1 P802.11wTM/D2.02

2
3 Draft ~~Amendment to~~ Standard for Information
4 Technology - Telecommunications and ~~Information~~
5 ~~Exchange Between Systems~~ information exchange
6 between systems - ~~LAN/MAN Specific Requirements~~
7 Local and metropolitan area networks -
8 Specific requirements -
9
10
11
12
13
14

22
23
24 Amendment ~~number~~ 5 : Protected Management
25 Frames
26
27
28
29
30
31
32

Figure 5-13—Establishing pairwise and group keys

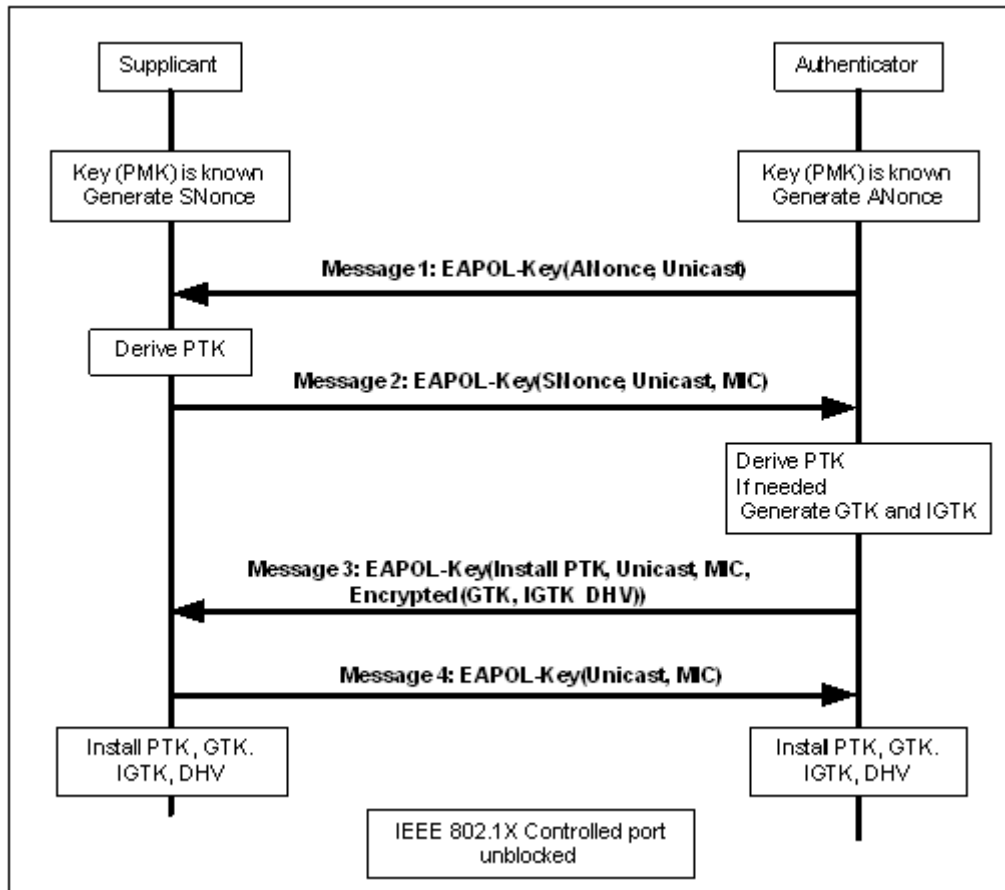
1 *Replace Figure 5-13 with the following figure, with the changes being the inclusion of “IGTK” in mes-*
2 *sage 3 and in both the Supplicant and Authenticator boxes that begin with “Install” and in the Authenti-*
3 *cator box to “Generate GTK and IGTK”:*
4
5
6

Figure 5-14 — Delivery of subsequent group keys

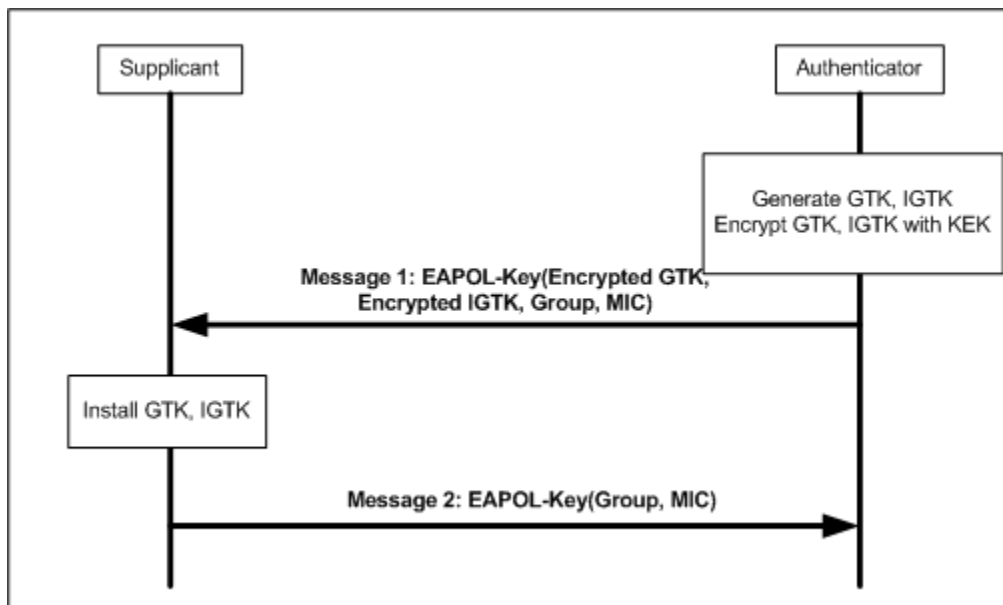
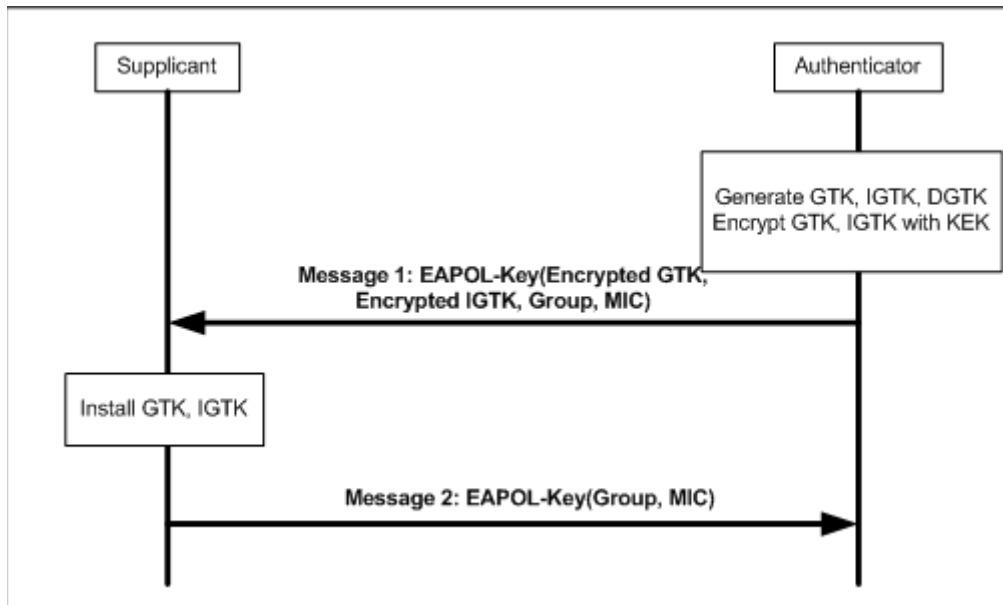
1 *Replace Figure 5-14 with the following figure, with the changes being the inclusion of “Encrypted*
 2 *IGTK” in Message 1, “IGTK” in the Authenticator box beginning with ‘Generate” and “IGTK” in the*
 3 *Supplicant box beginning with “Install”;* the update to the 2nd box on the right has *intentionally-intention-*
 4 *ally fixed from the 802.11ma D9.0 draft 11-2007 to correctly state “Encrypt GTK, IGTK with KEK”:*
 5
 6
 7
 8

Figure 8-18 — Nonce Construction

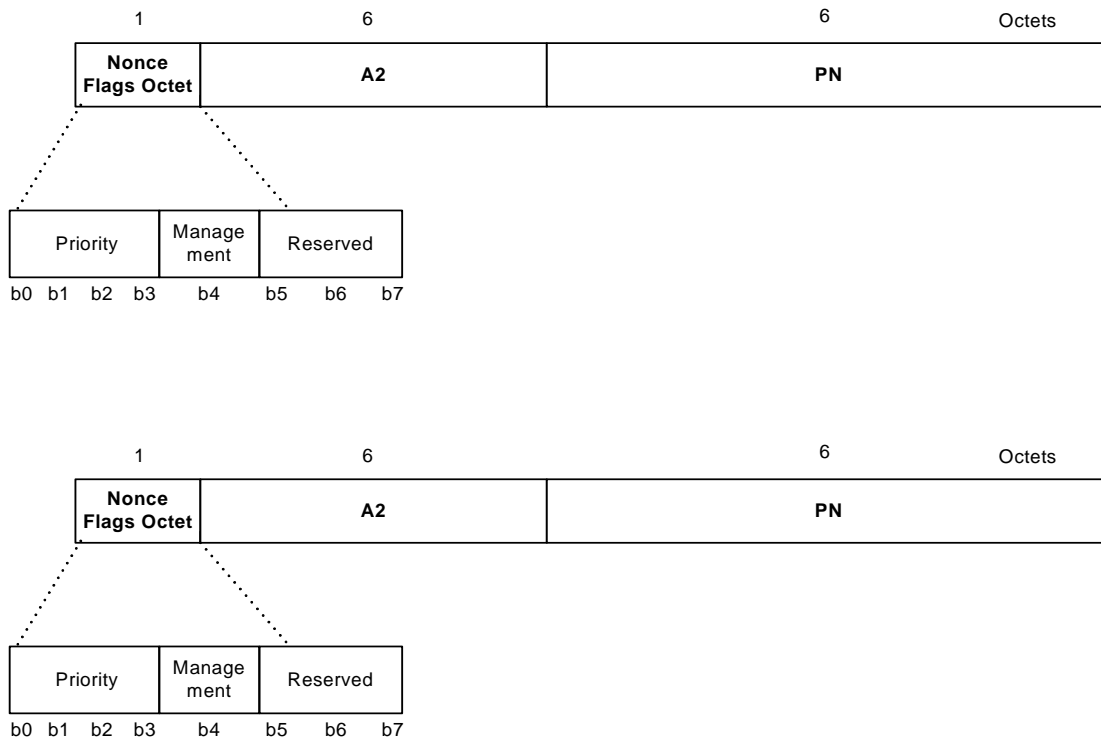
62
63 *Replace Figure 136 with the following figure ~~replacing "Priority Octet" with "Nonce Flag Octet", and~~*
64 *addition of "Management" as bit 4 of this octet."*
65

EDITORIAL NOTE: ANA must be requested for this bit (4). There ~~has~~ *have* been issues editing the above Figure and thus is left as B4....readers should note that until ANA assigns this bit, it should read ~~TBD~~ <ANA>, pending ANA assignment.

Figure 8-19a — BIP Encapsulation

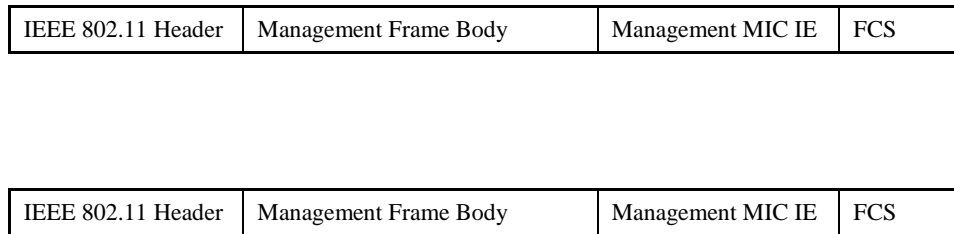
The Management MIC IE shall follow all of the other IEs in the management frame body but precede the FCS. See ~~7.3.2.51~~ 7.3.2.54 for the format of the Management MIC IE. Figure ~~137wa-8-19a~~ 8-19a shows the BIP MMPDU.

Figure 8-33—Sample 4-Way Handshake

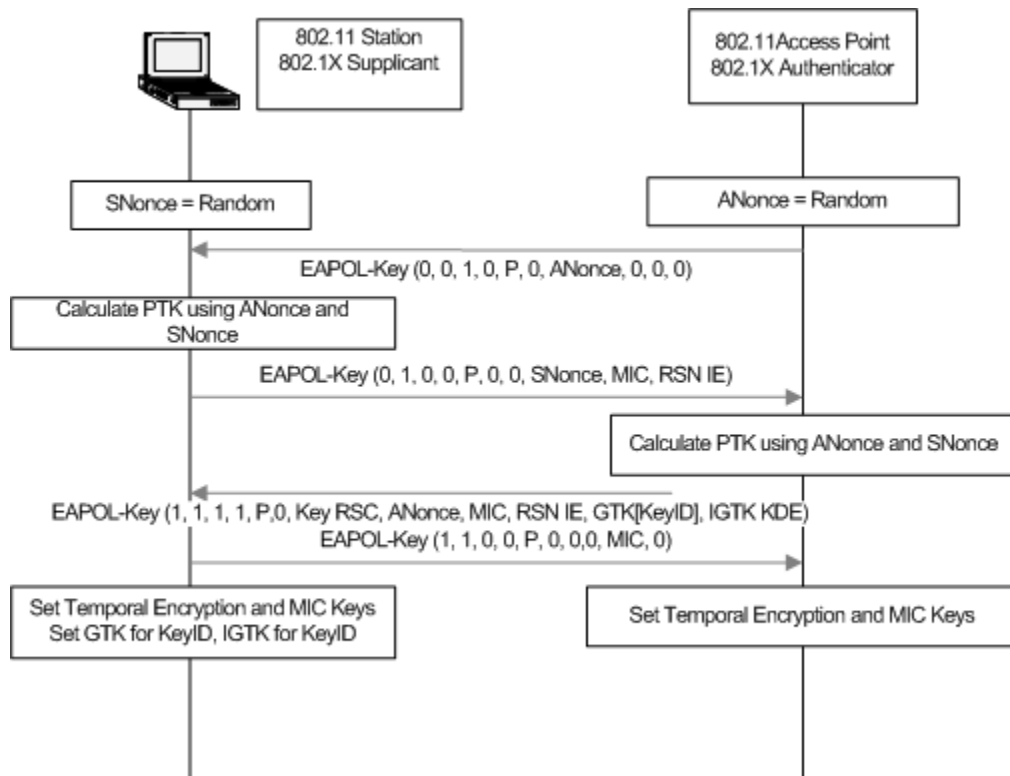
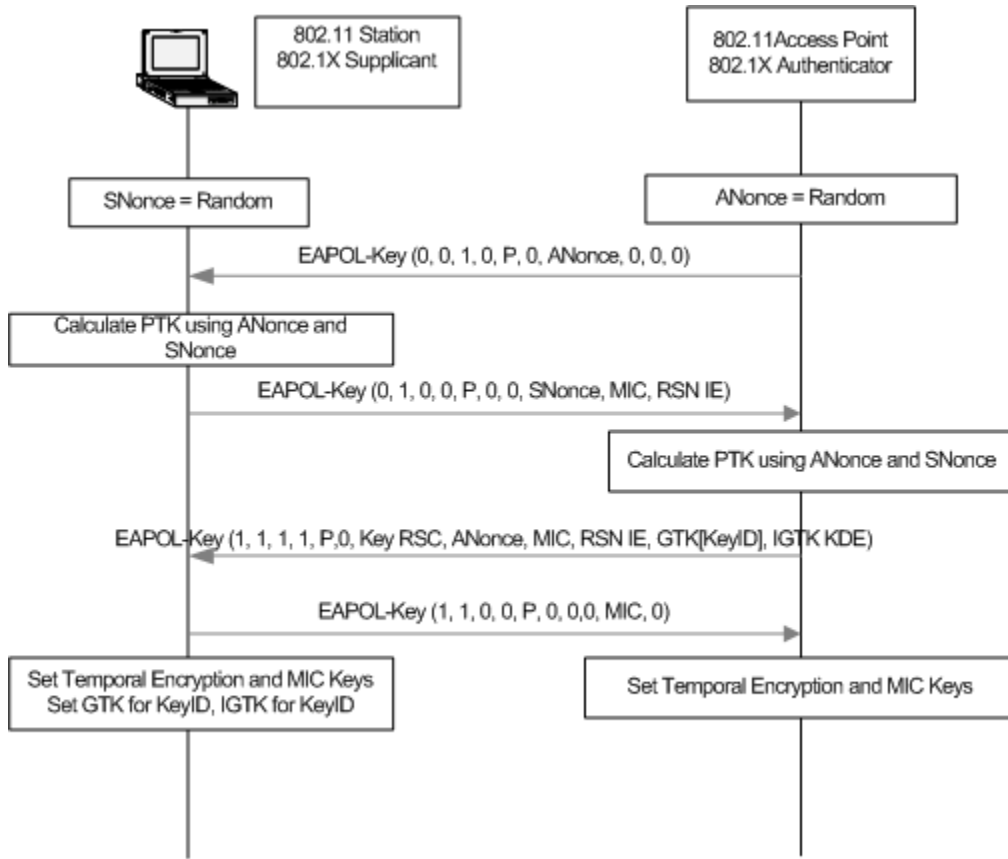
Replace Figure 151 with the following Figure, with the ~~updated~~ updates including IGTK KDE on the 3rd EAPOL-Key message and "IGTK Key ID" on the 3rd supplicant box:

Figure 8-34—Sample Group Key Handshake

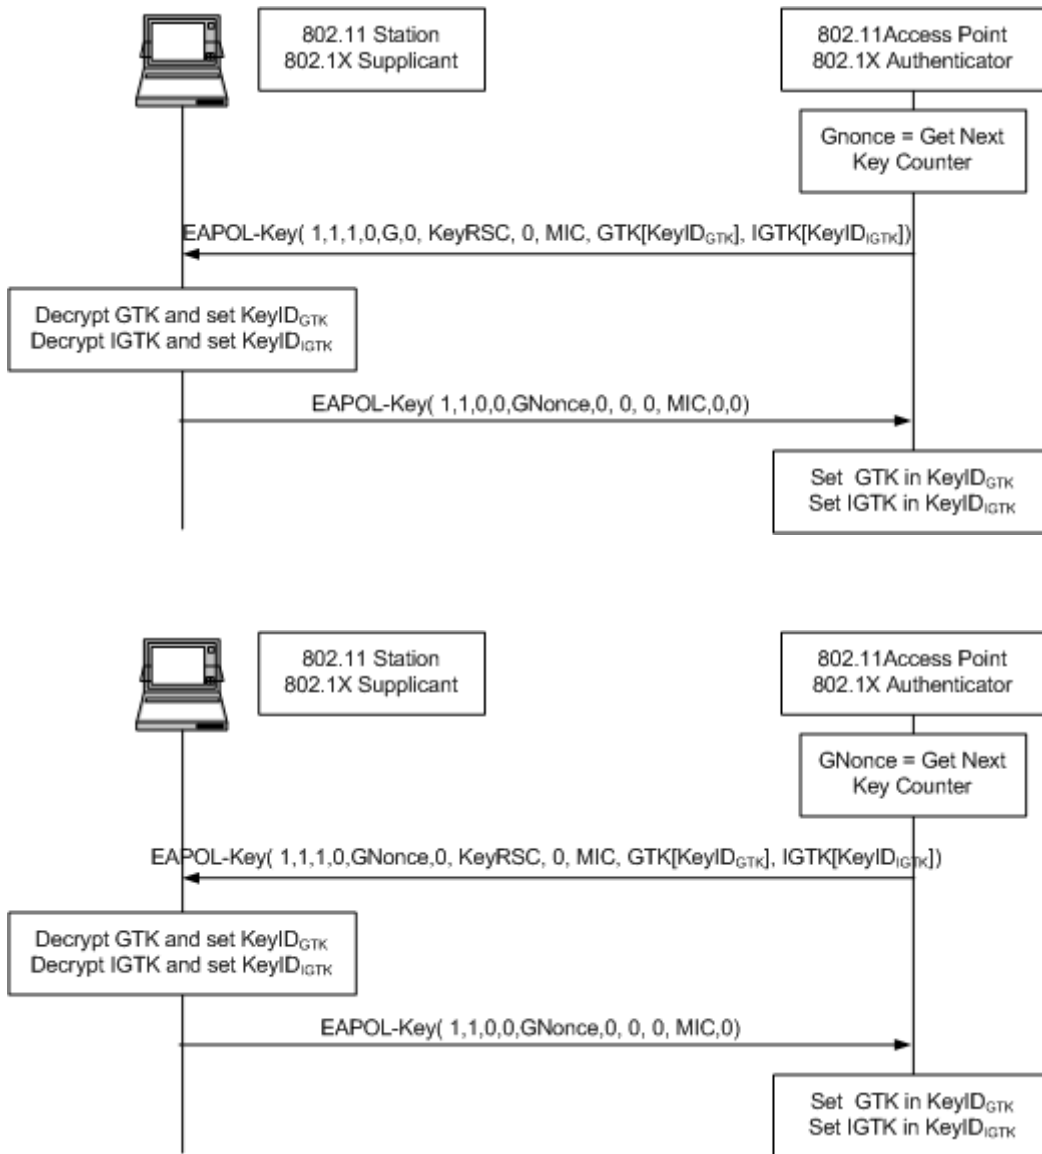
1 *Replace Figure 152-8-34 with the following Figure, with the updated updates including IGTK on the first*
 2 *EAPOL-Key message and 2nd supplicant box, adding "0,0" on reformatting the first message above the*
 3 *second EAPOL-Key message arrow and IGTK and new subscripts to the last Authenticator box:*
 4
 5
 6
 7

Figure 8-35—RSNA Supplicant key management state machine

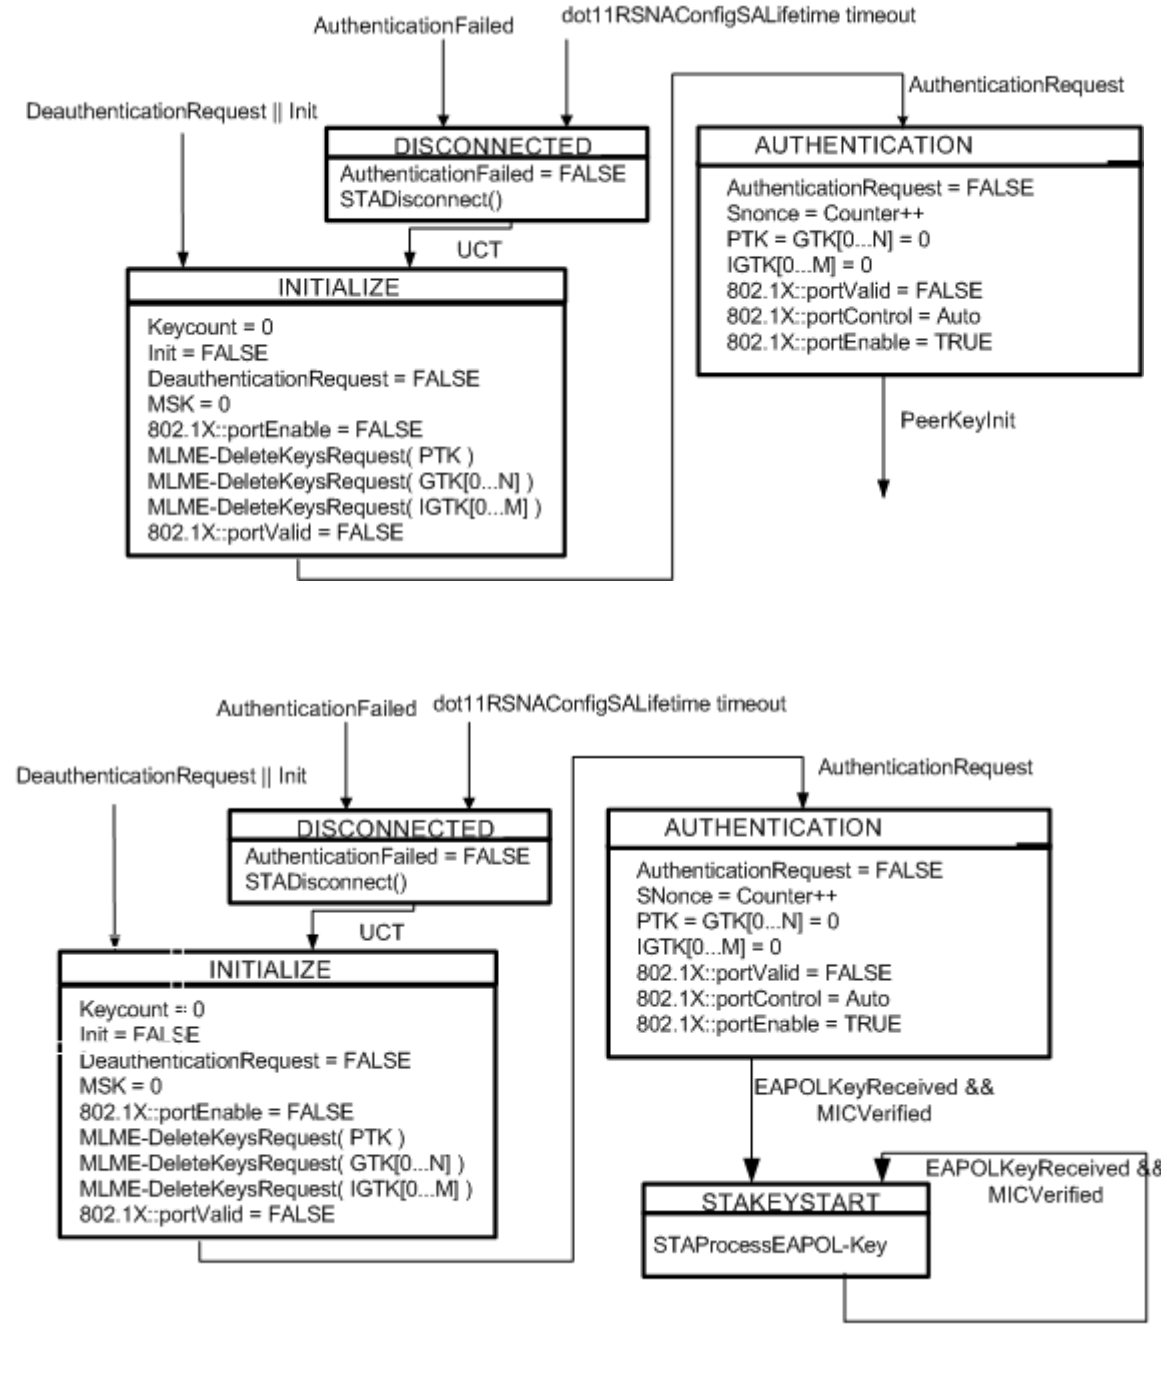
Replace Figure 153-8-35 with the following figure updating “Snonce” to “SNonce”, adding “IGTK[0...M] = 0” in the “AUTHENTICATION” box and “MLME-DeleteKeysRequest(IGTK[0...M])” to the “INITIALIZE” box:

Figure 8-40—Authenticator state machines, part 44

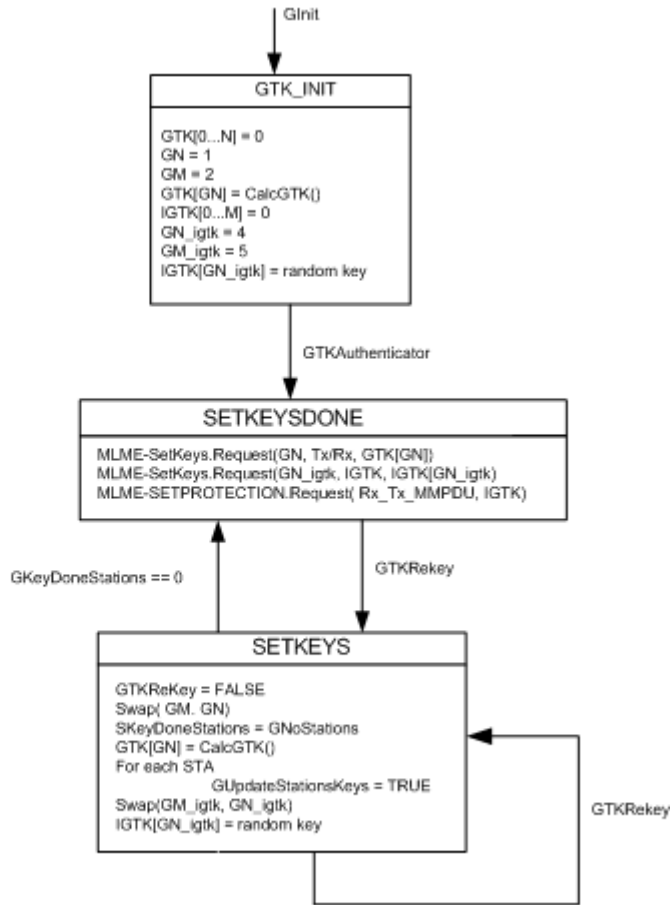
1 *Replace Figure 8-40 with the following Figure, with the updates being the addition into the GTK_INIT*
 2 *state (semicolons showing linebreaks): “IGTK[0..M] = 0; GN_igtk = 4; GM_igtk = 5; IGTK[GN_igtk] =*
 3 *random key”;* *addition into SETKEYSDONE state: “MLME-SETKEYS.request(GN_igtk, IGTK,*
 4 *IGTK[GN_igtk]); MLME-SETPROTECTION.request(Rx_Tx_MMPDU, IGTK)”.* *Addition into SET-*
 5 *KEYS state: “Swap(GM_igtk, GN_igtk); IGTK[GN_igtk] = random key”.insertion of “IGTK[M]” in the*
 6 *PTKINITNEGOTIATING box:*
 7
 8
 9

Figure 11A-13—Authenticator R1KH state machine (part 1)

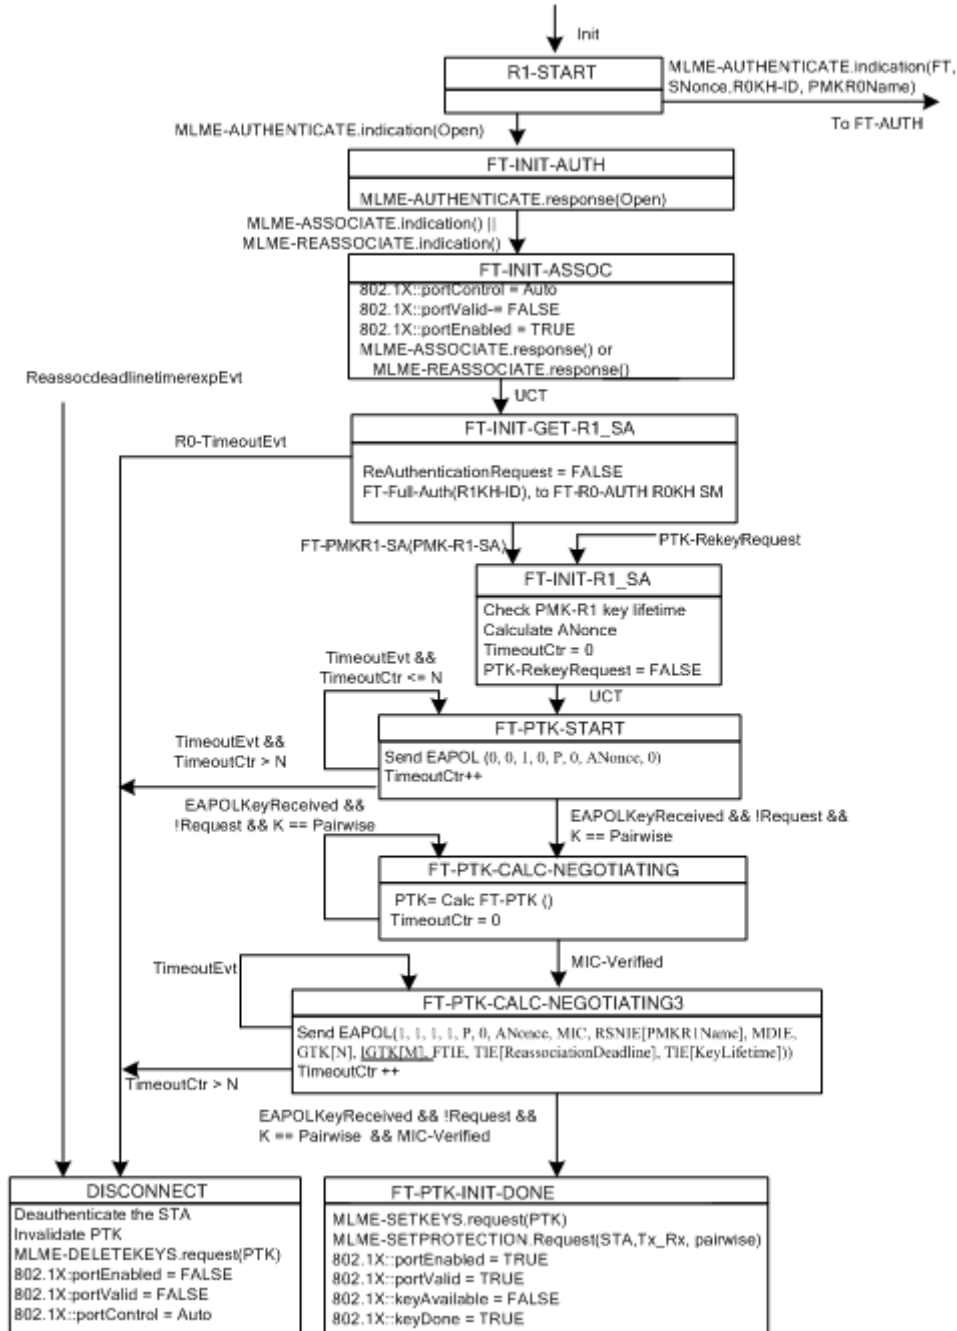
Replace Figure 11A-13 with the following Figure, with the updates being including “IGTK[M]” in the FT-PTK-CALC-NEGOTIATING3 box:

Figure 11A-14—Authenticator R1KH state machine (part 2)

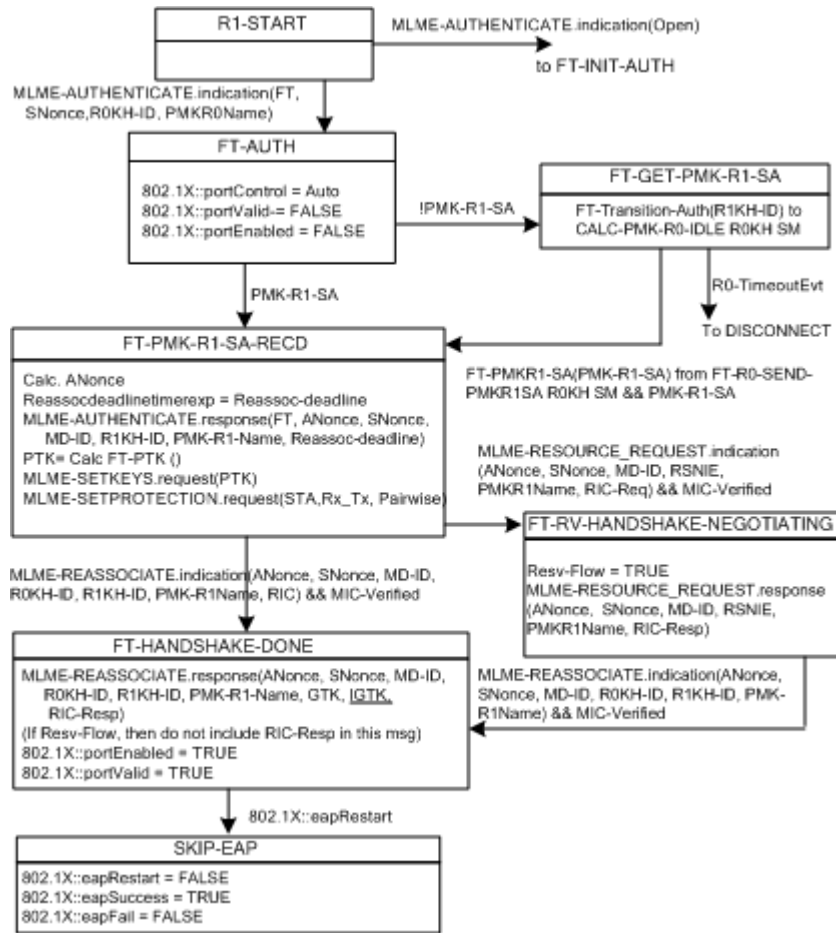
Replace Figure 11A-14 with the following Figure, with the updates being including "IGTK" in the FT-HANDSHAKE-DONE box:
